2021 GROUP A PROPOSED CHANGES TO THE I-CODES

April 11 – May 5, 2021
Virtual Committee Action Hearings

2021 GROUP A – PROPOSED CHANGES TO THE INTERNATIONAL BUILDING CODE – GENERAL

FIGURE 722.5.1(5)

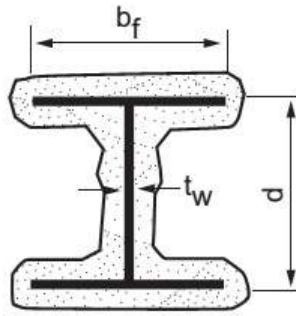
WIDE FLANGE STRUCTURAL STEEL COLUMNS WITH SPRAYED FIRE-RESISTIVE RESISTANT MATERIALS

722.5.1.3 Sprayed fire-resistant materials. (SFRM). The fire resistance of wide-flange structural steel columns protected with SFRM sprayed fire-resistant materials, as illustrated in Figure 722.5.1(5), shall be permitted to be determined from the following expression:

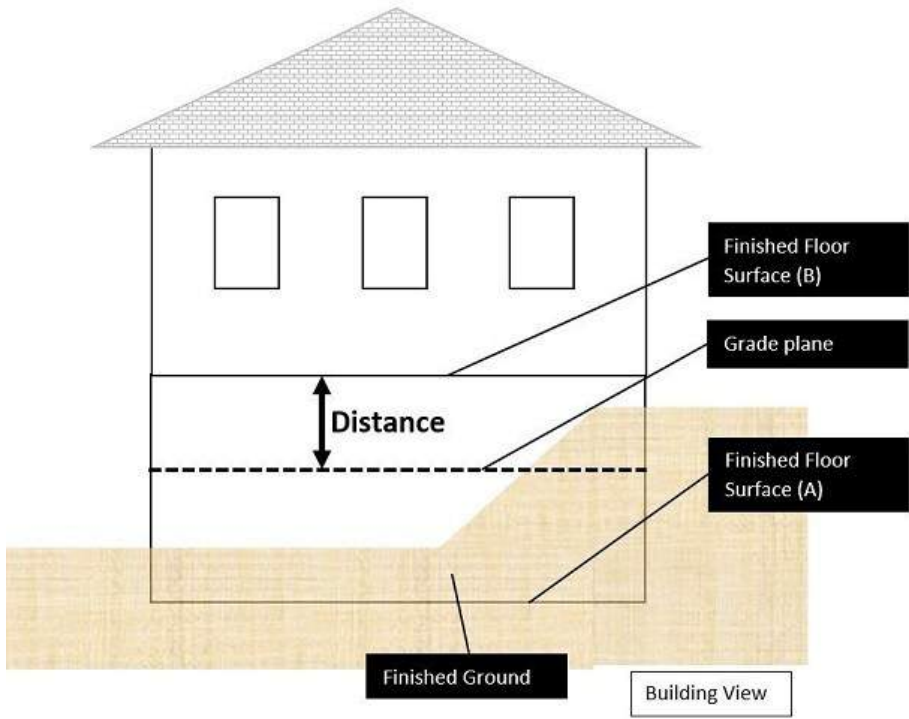
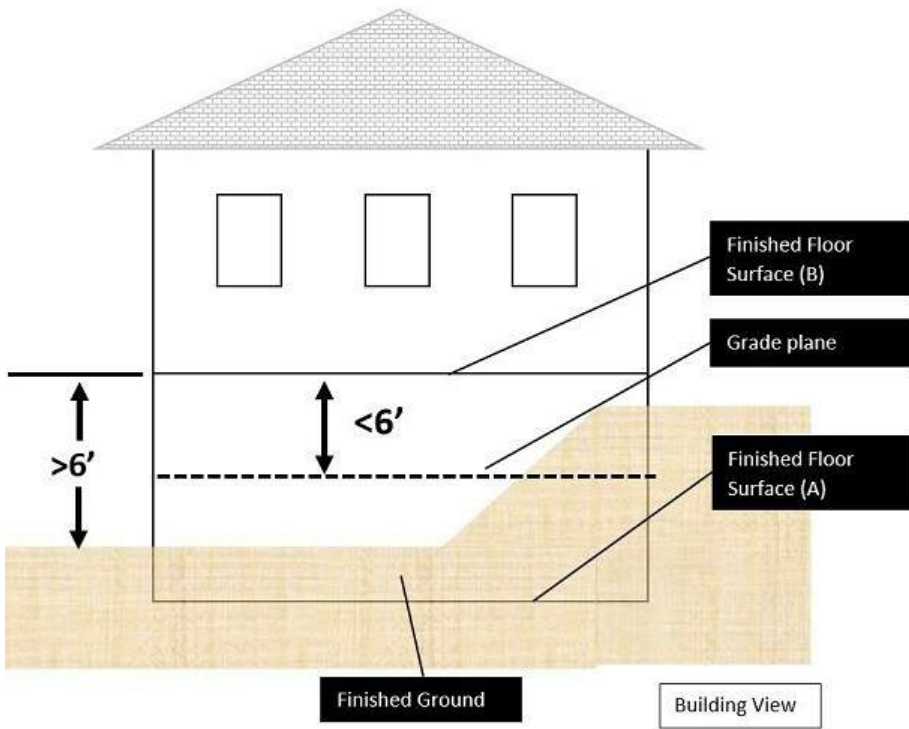
Reason Statement: When the entirety of a finished floor surface is not above *grade plane* the current code provisions describe two different scenarios that will still define it as a *story above grade plane*. The first provision specifies that the finished floor surface will be considered a story above *grade plane* if the finished story next above is more than 6 feet (1829 mm) above *grade plane*, where *grade plane* is defined as a "reference plane representing the average of the finished ground level adjoining the building at all exterior walls." A hypothetical simple example can be imagined with a level finished ground level, which is shown below, that fulfills this requirement.

Not all buildings and dwellings are constructed on level finished ground and can instead be constructed on uneven finished ground as shown below. According to the current code provisions, if the dimension labeled 'distance' is greater than 6' then the finished floor surface (A) corresponds to a *story above grade plane*.

The proposed change to the code applies to the figure below because more than 50 percent of the total building perimeter is more than 6 feet (1829 mm) above the finished ground level. In the figure below the current code provisions would not characterize the finished floor surface (A) as part of a story above grade plane and would instead finished floor surface (B) would apply to the first story above grade plane.

Figure 4. Comparison of Building Heights for Group R-1 and R-2 sprinklered occupancies based on proposed code change.

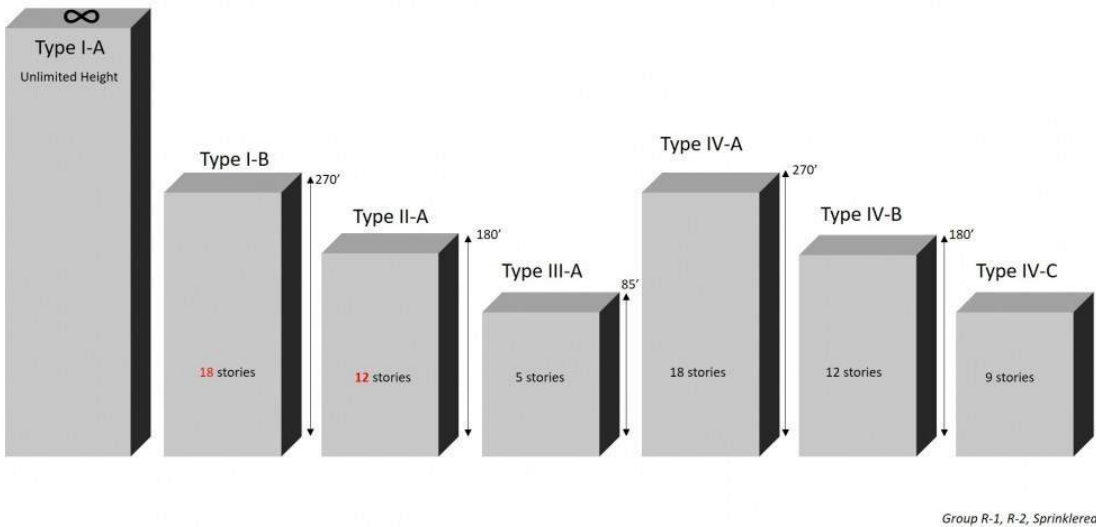
For the proposed code change, Figure 4 illustrates no increases to building height over what is permitted by Section 403.2.1.1, and does not intend to present any decrease in the level of safety from the previous code edition based on the introduction of footnote i.

Figure 1. Sprinkler express risers or standpipes in high-rise buildings having a building height less than 420 ft.

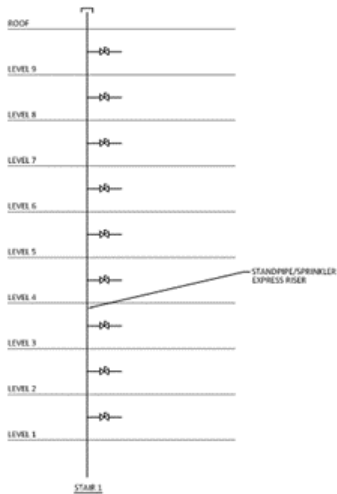
Figure 1 shows the configuration for a single *vertical water supply zone* in a building having a *building height less than 420 feet (128 m)*.

Figure 2. Sprinkler express risers or standpipes in high-rise buildings having a building height greater than 420 ft.

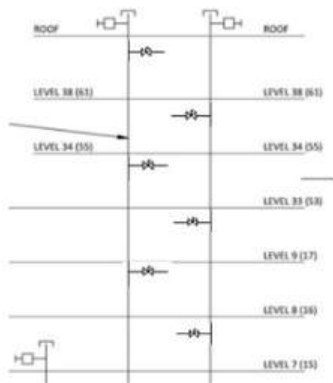
The change also clarifies that two *standpipes* or *sprinkler express risers* are needed to supply sprinkler systems in buildings having a *building height* greater than 420 ft. Figure 2 shows the configuration for a building having a *building height greater than 420 ft*.

Figure 503.1 Location of PV Support Structures on Open Parking Structures.

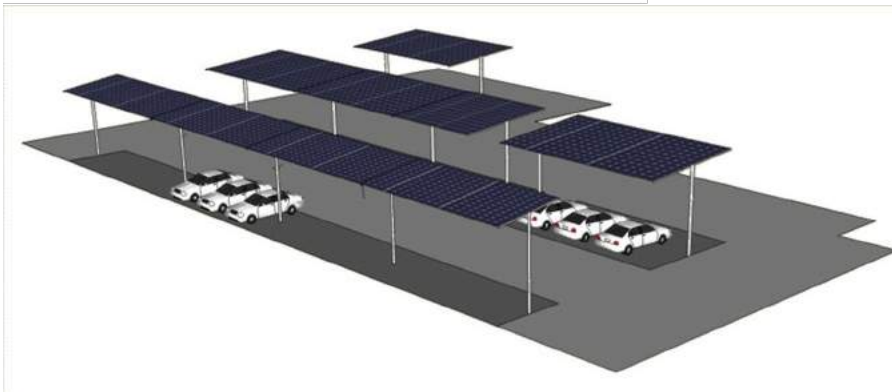
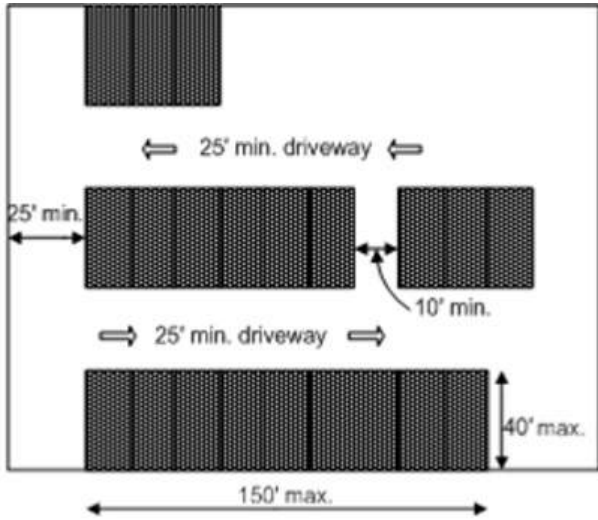
- 1.2.1. 10 feet (3050 mm) above the allowable building height.
 - 1.2.2. 10 feet (3050 mm) above the roof of the building immediately below.
2. Photovoltaic (PV) support structures installed on the roof of an open parking structure shall not constitute an additional story or additional floor area and shall be permitted to exceed the height limit of a building where all the following conditions are met (see Figure 503.1):

- 2.5. PV support structures are completely open on all sides, other than necessary structural supports, with no interior partitions.

Diagram for elevator lobby

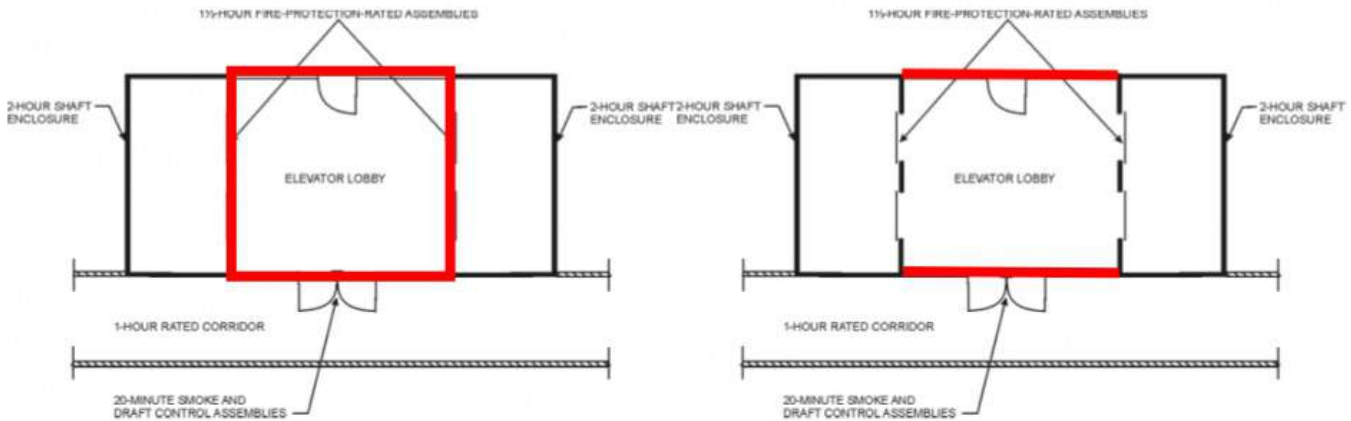
710.4.1 Smoke partition walls enclosing elevator lobbies. Smoke partition walls used to enclose elevator lobbies in accordance with Section 3006.3 (elevator hoistway protection), shall form an effective enclosure that terminates at a fire barrier having a level of fire-resistance-rating not less than 1 hour, another smoke partition or an outside wall.

Reason Statement: The intent of this proposal is to clarify lobby protection requirements – which walls are fire barriers, fire partitions or smoke barriers. This will also clarify what requirements are applicable for the elevator hoistway doors vs. the doors in the other walls of the lobby protection. The current language is inconsistent for the locations where elevator lobbies are specified. This protection of elevator lobbies is a combination of the elevator hoistway and exit stairway (direct access to a stairway is required for fire service an occupant evacuation elevator lobbies) shaft enclosure/fire barriers and the fire partitions or smoke barriers required for lobbies (405.4.3, 3006.3, 3007.6.2 and 3008.6.2) The intent of new 708.4.1 and revised 709.4.2 is to clarify that the fire partitions/smoke barrier criteria is not applicable to all the walls of the elevator lobby since the vertical shaft/fire barrier protections is adequate. Fires typically happen in the occupied portions of the buildings, not within the elevator shaft or the stairway. In addition, in situations where an elevator lobby is provided, the elevator shafts are double protected from smoke intrusion from a fire on the floor.

FIGURE 3115.3.2
MARKING IDENTIFICATION AND LIKELY LAYOUT

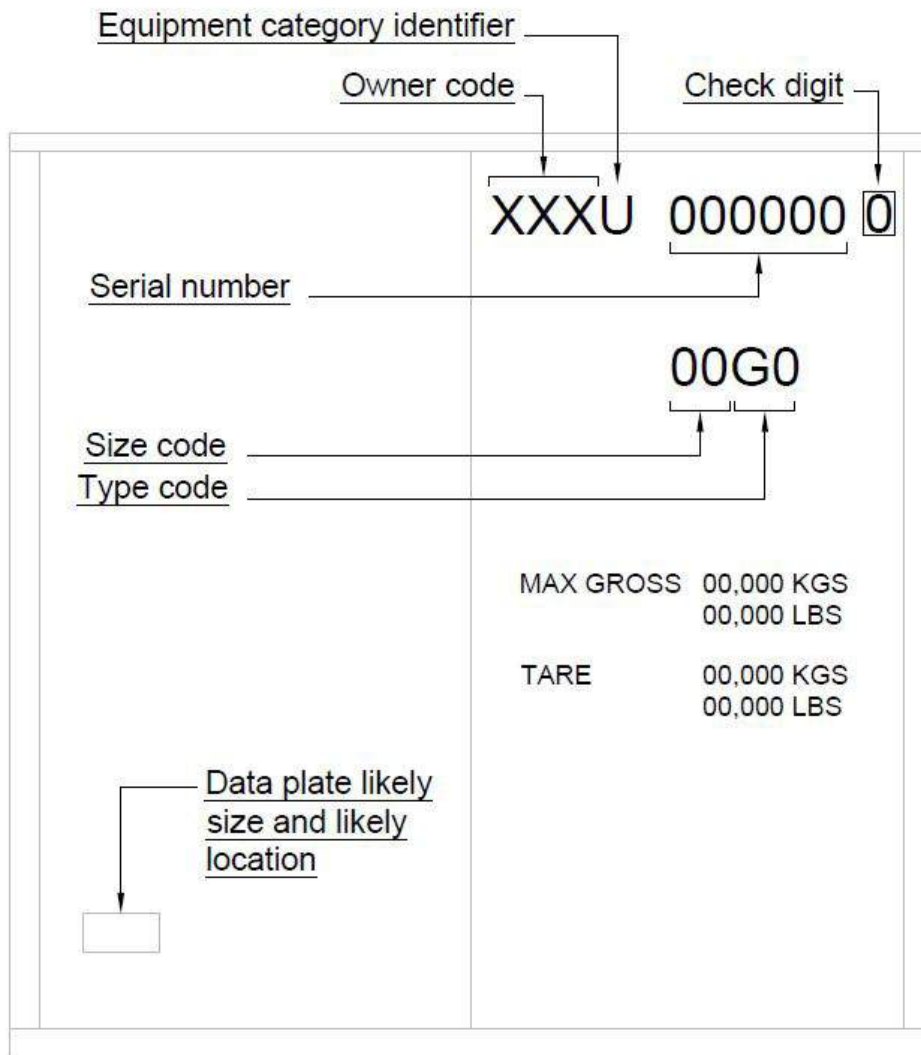
3115.3.2 Intermodal shipping container markings. *Intermodal shipping containers shall have markings, separate from the data plate, containing the following information. Refer to Figure 3115.3.2 for an example layout of the markings.*

1. An owner code consisting of three letters.
2. An equipment category identifier that shall be the letter U. This equipment category identifier is grouped with and immediately follows the owner code.
3. A six digit serial number.
4. A check digit in a box.
5. A two digit size code.
6. A type code of two letters. The first letter shall be G, V, U, B, or S. This type code is grouped with and immediately follows the size code.
7. Maximum gross mass (kgs) (lbs).
8. Tare mass (kgs) (lbs).

**FIGURE 3115.8.3.4
CONTAINER ELEMENT IDENTIFICATION**

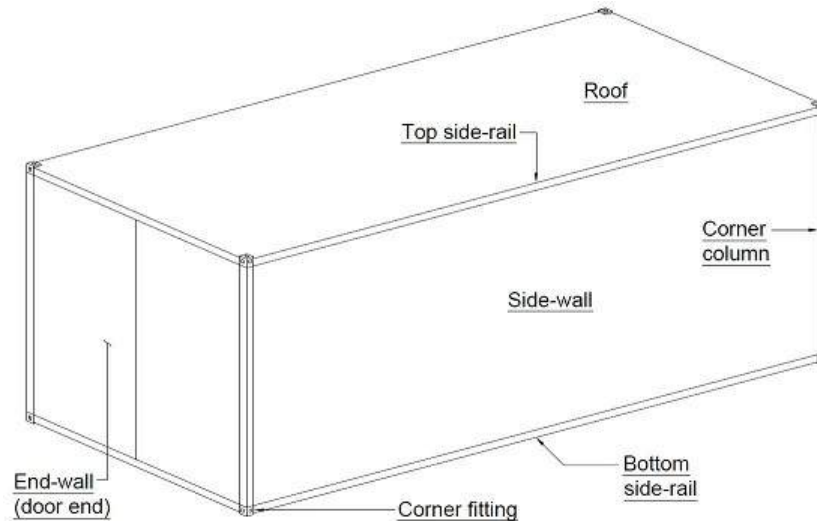
3115.8.3.4 Tested structural components. Where they are not altered, the structural components identified in Section 3115.8.3.4.1 and 3115.8.3.4.2 can be used with the load combinations of Section 1605.3 based on the testing performed during the *intermodal shipping container* certification process. This certification shall have been verified by the data plate and markings in Section 3115.3.

The components names are labeled in Figure 3115.8.3.4.
